An Addition to HORIZON ELEMENTARY SCHOOL

Jerome School District
Jerome, Idaho

December 17, 2021

This approval shall not be construed to be an approval of any violation of, or variance from, Idaho's adopted codes, standards, laws or rules applicable to this project.
SEPARATE BUILDING PERMIT REQUIRED FOR CONSTRUCTION

Code Study Floor Plan
 3/32" = 1'-0"
 NORTH

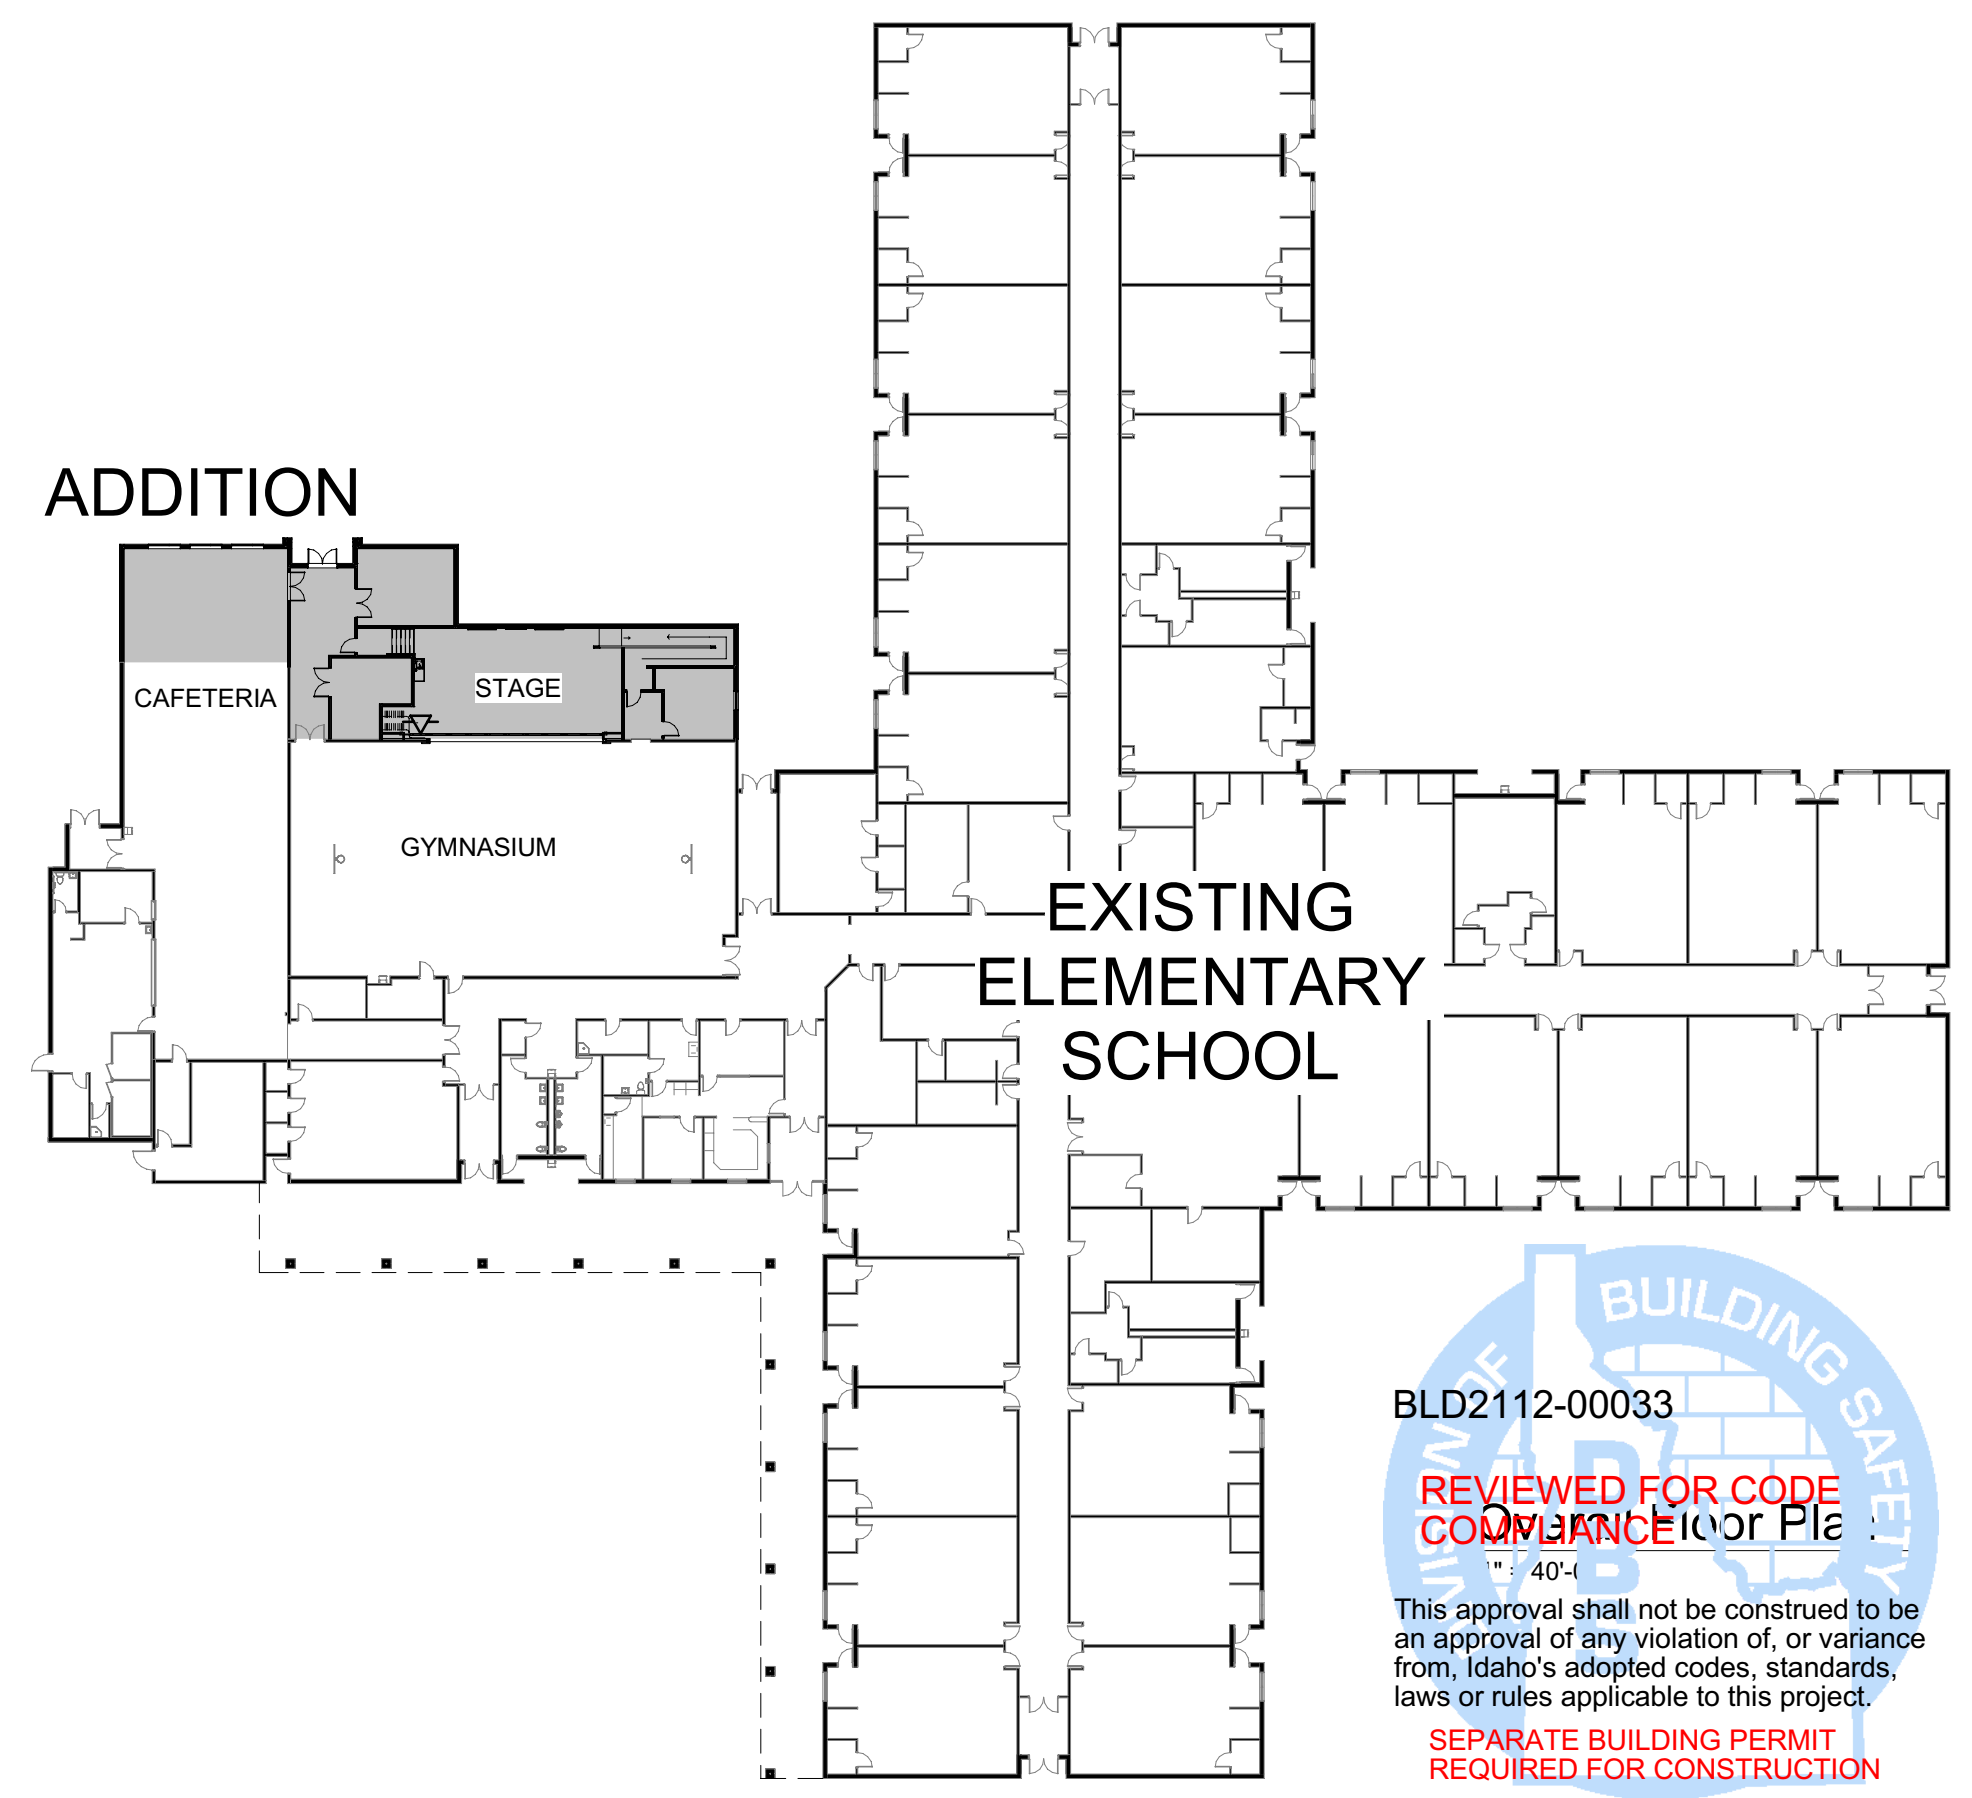
These walls are required to be constructed as 1hr. fire barriers for compliance with section 410.4.1 of the 2018 IBC. Fire barriers shall comply with section 707 of the 2018 IBC. Adherence to a listed fire resistance rated system and the IBC shall be verified through on-site inspections.

4 Door Jamb

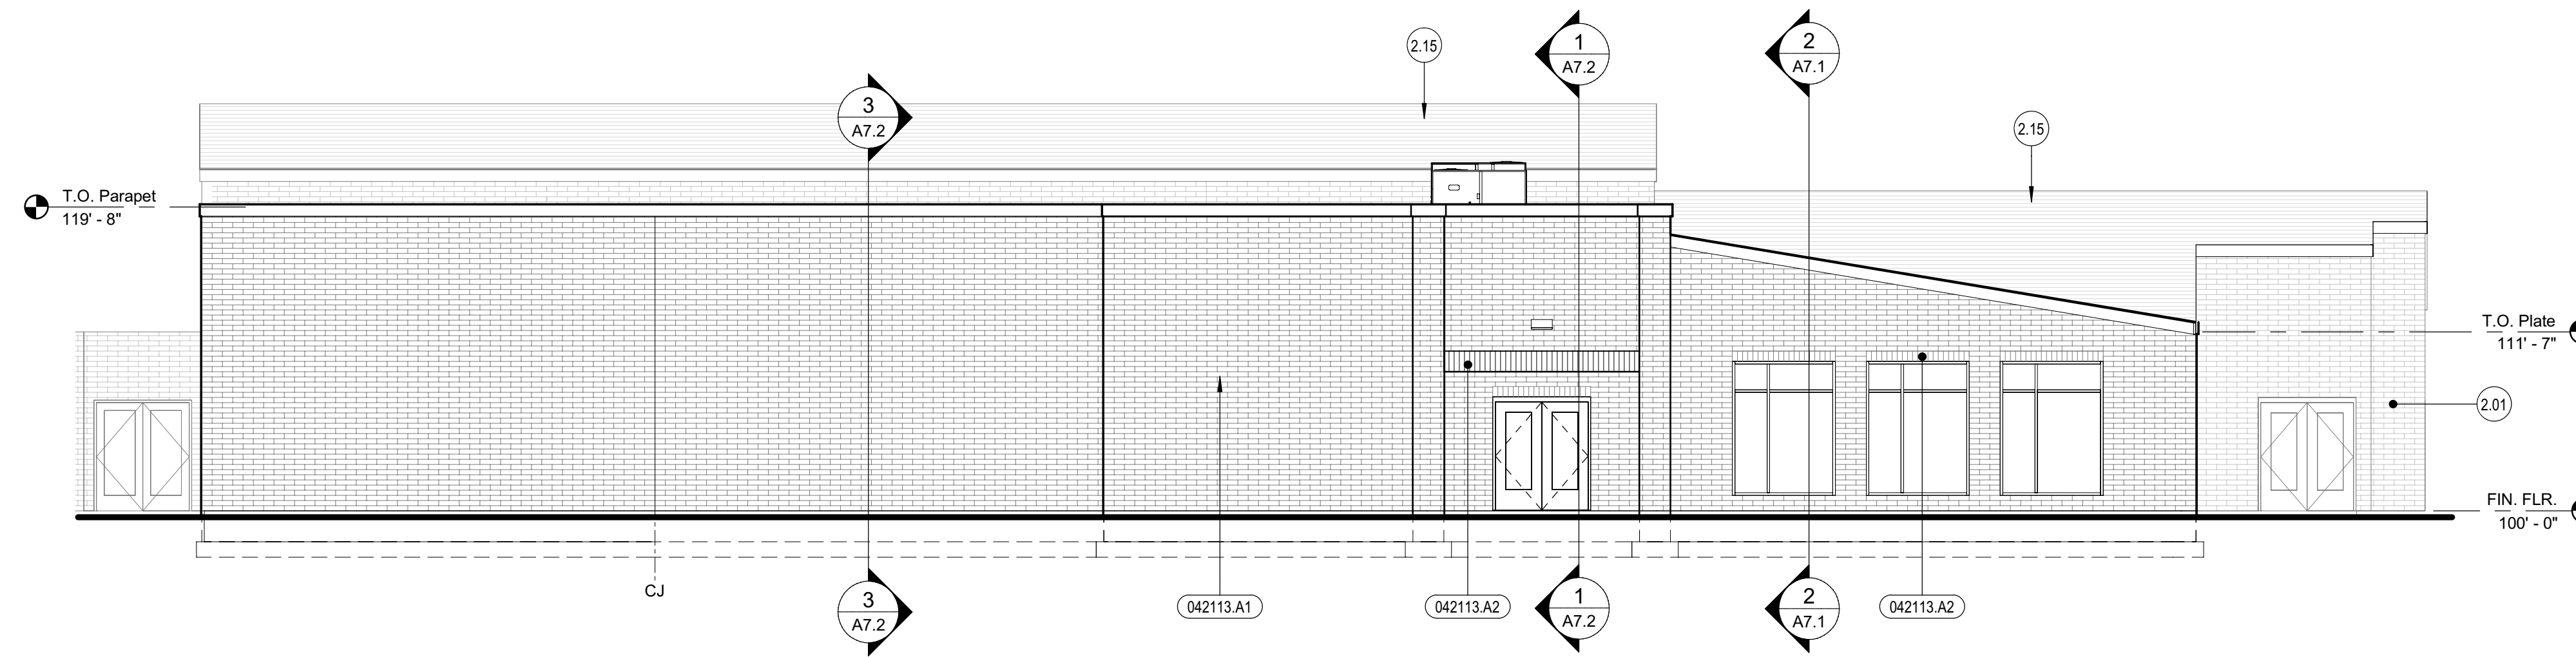
These doors shall meet the fire rating requirements of section 716 of the 2018 IBC. See the plan review notes on the code plan for more information.

DRAWING NO.:
E0.0
ELECTRICAL SYMBOLS AND SHEET INDEX

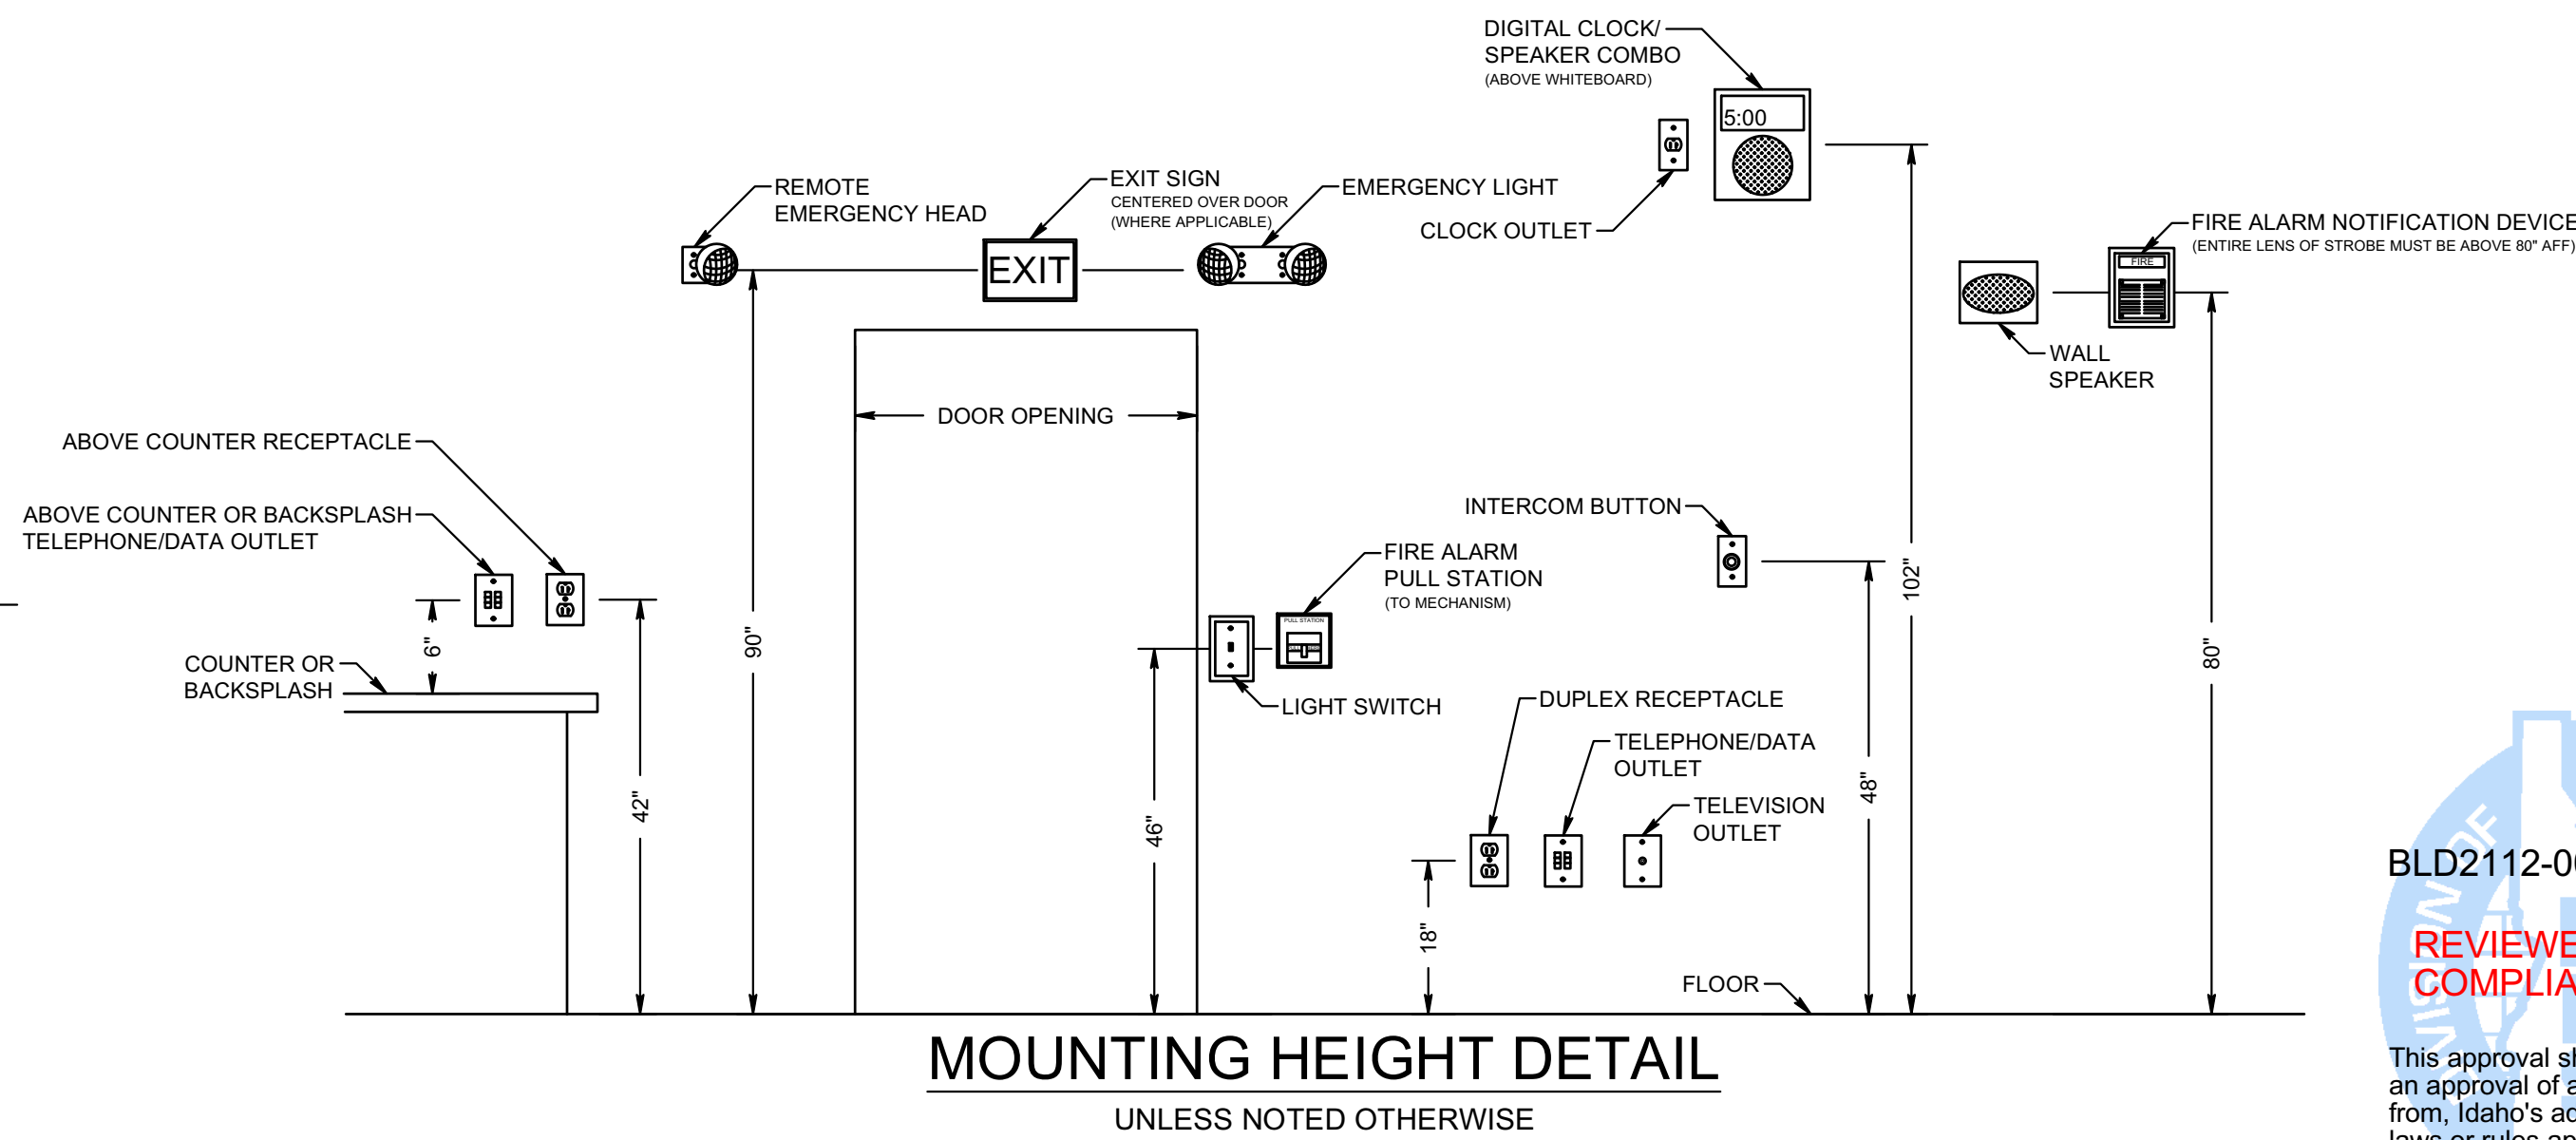
Electrical Plan Review Note:
The stamped documentation has been Reviewed for Compliance in accordance with the NEC as adopted by the State of Idaho by an Electrical Plan Review. This shall not be construed as an approval of any violation of, or variance from Idaho's adopted codes, laws, standards, or rules. Final approval will be based upon on-site electrical inspections to field verify compliance. (Additional Electrical Plan Review Notes can be found on additional Electrical Drawing Sheets.)
